**SUBDIVISION
PLANNED UNIT DEVELOPMENT,
ZONING AMENDMENT,
& SIDEWALK WAIVER STAFF REPORT**

Date: October 19, 2017

Coast Safe & Lock Subdivision

SITE PLAN

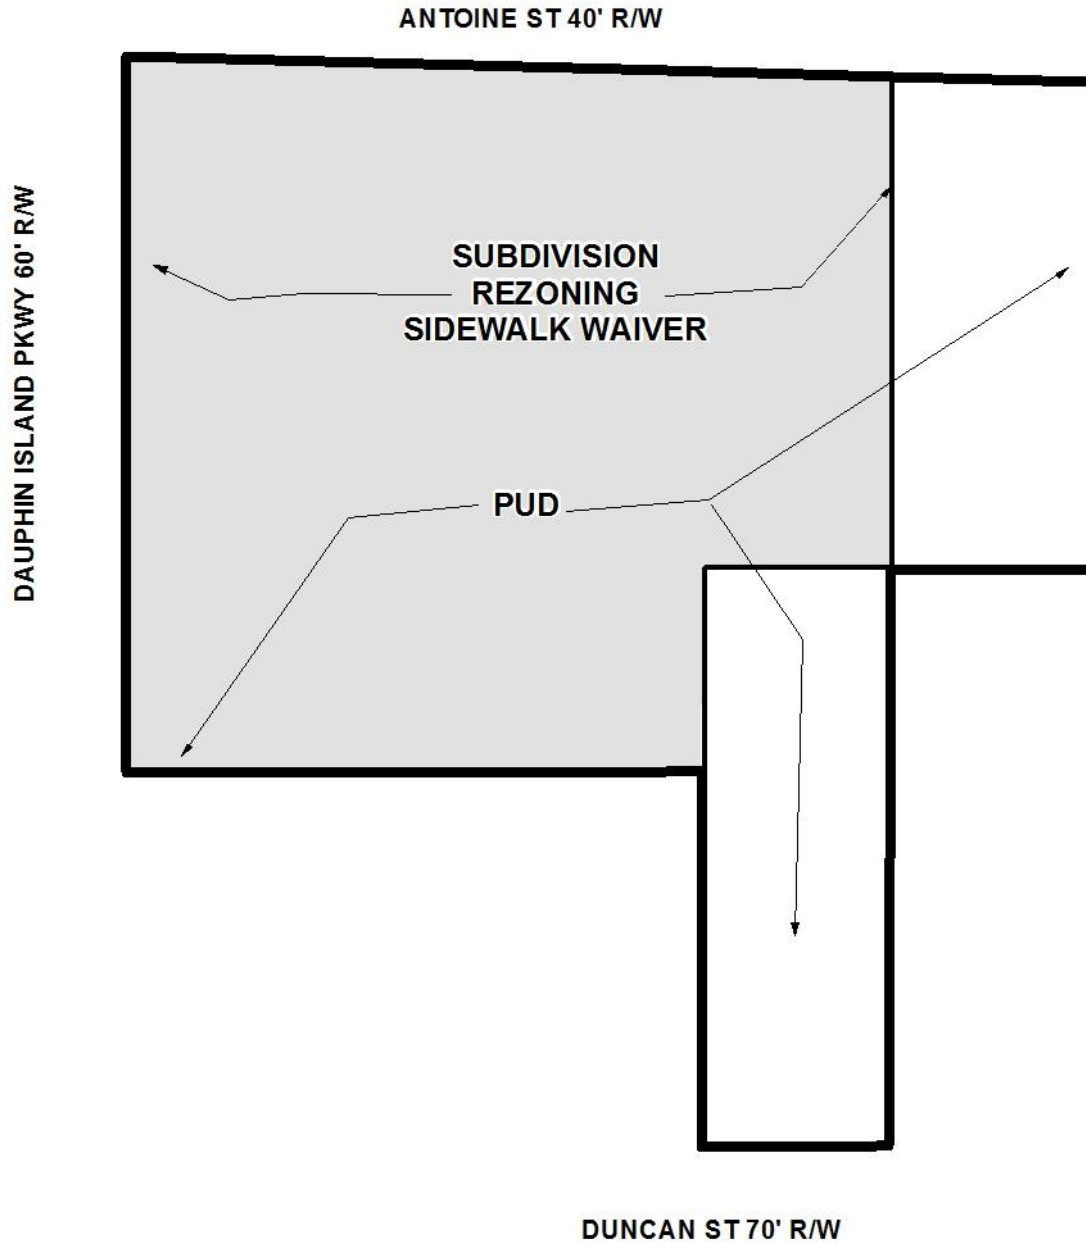
The revised site plan depicts the removal of some of the existing head-in parking along Dauphin Island Parkway, with it being replaced by landscape area and understory trees. Nine (9) parking spaces, that will back into the Dauphin Island Parkway right-of-way, are proposed to remain (eleven were previously depicted).

The new parking area that will be accessed from Antoine Street has been reduced in size, and is now proposed to contain only three (3) parking spaces (five were previously depicted). The curb-cut width has been reduced from approximately 48 feet to approximately 30 feet. Additional landscape area and understory trees are provided where parking was previously proposed. The redesign of this proposed parking area will result in vehicles backing into Antoine Street, whereas the previous design provided some space on site for maneuvering to perhaps allow head-out access.

Behind the main entry into the gated parking area from Dauphin Island Parkway, the site plan has been revised to depict the provision of six (6) overstory trees along the south property line.

The revised plan depicts two recycling dumpsters located within the interior of the property, away from street and abutting property lines. The dumpsters were not shown on the prior plan, and they were located within the setback along Antoine Street and within the residential setback area near the Duncan Street residence.

The revised site plan shows that a sidewalk will be provided along Antoine Street up to the eastern edge of the new parking area, and terminated from that point to the east side of the PUD.

A minimum building setback line is not depicted on the PUD site plan. Also, right-of-way dedication does not appear to be proposed along Antoine Street. As such, a 25-foot minimum building setback (which would apply to new building construction) should be depicted along each street frontage.

Planned Unit Development: The request is recommended for Approval, subject to the following conditions:

- 1) *Depiction of the minimum building setback line to be 25-feet from each street;*
- 2) *Provision of trees and landscaping as proposed on the revised PUD site plan;*

- 3) *Provision of 13 trees to the Tree Bank prior to the completion of any site improvements;*
- 4) *Provision of a 6 to 8 foot wooden privacy fence as proposed, with the removal of barbed-wire from that portion of the PUD site that is within a residential district, or successful application to the Board of Zoning Adjustment to allow the barbed-wire in the residential district;*

DETAIL SITE PLAN

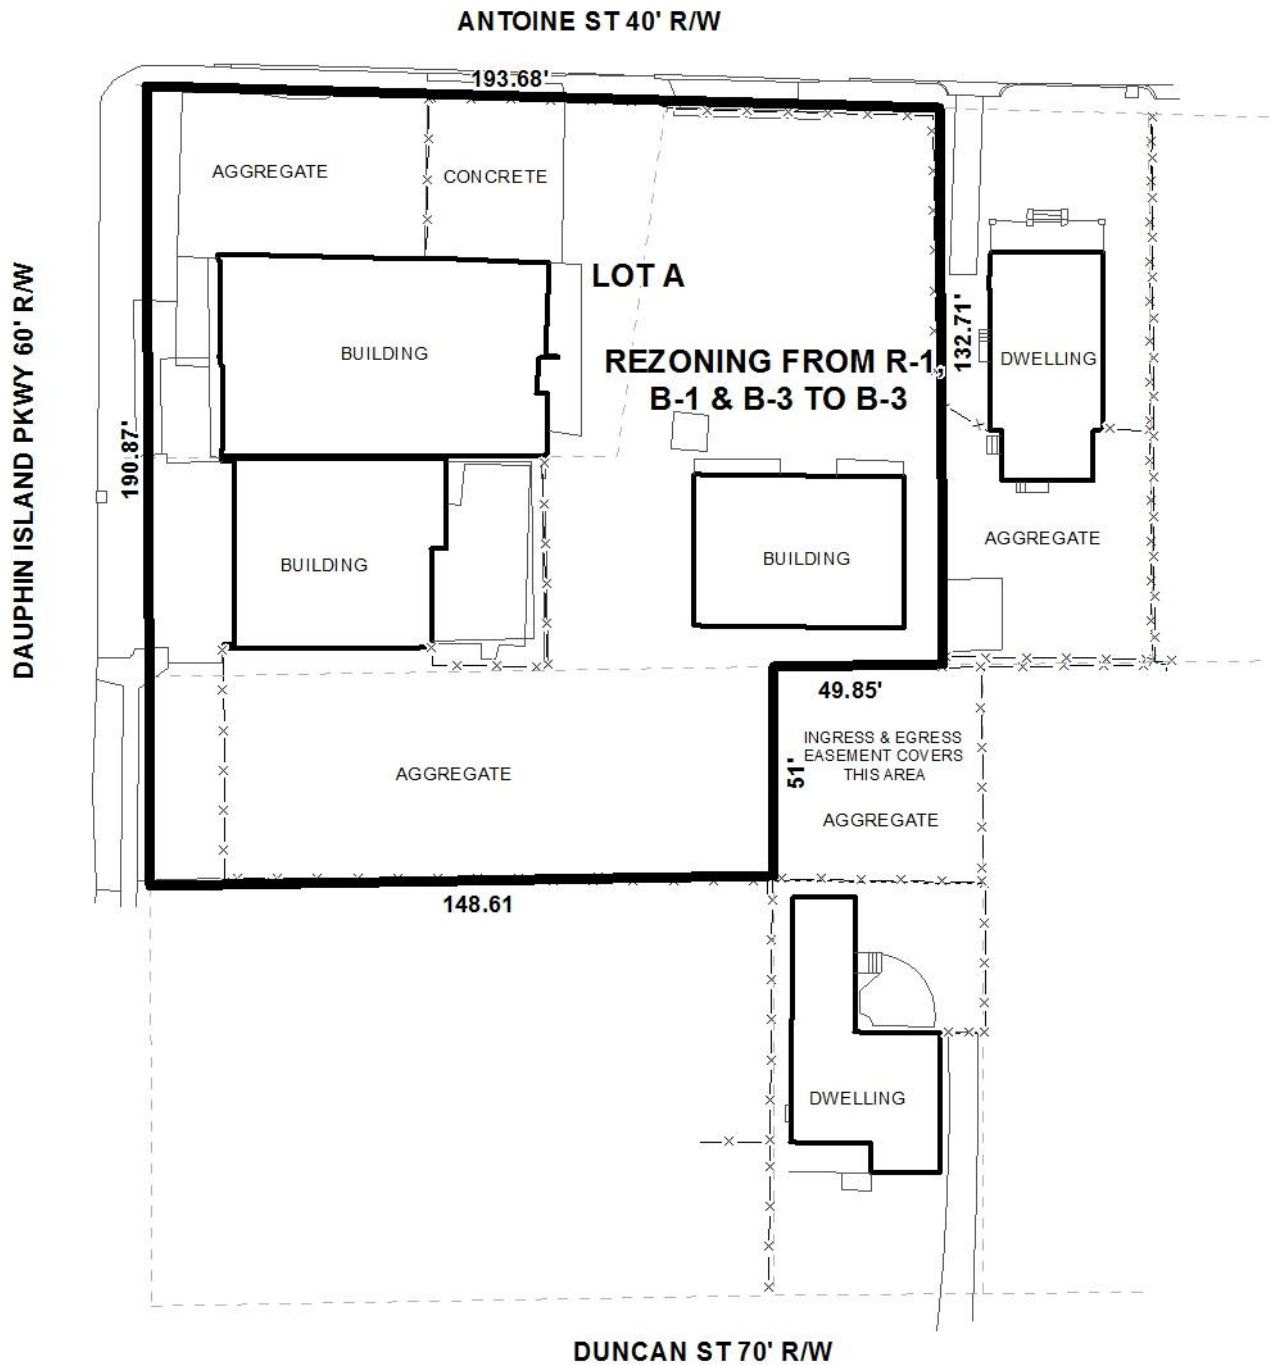
1. Compliance with the landscaping requirements (with donated trees).
2. Revised parking layout and entrances along DIP and Antoine streets.
3. All areas between the building & street not used for parking and sidewalks will be landscape areas.
4. The perimeter fence will be upgraded to a 6 ft. privacy fence with barbed wire security to screen the employee parking and loading areas.
5. The recycle dumpsters are relocated and screened from view.
6. Domestic garbage will be handled with a separate trash bin.
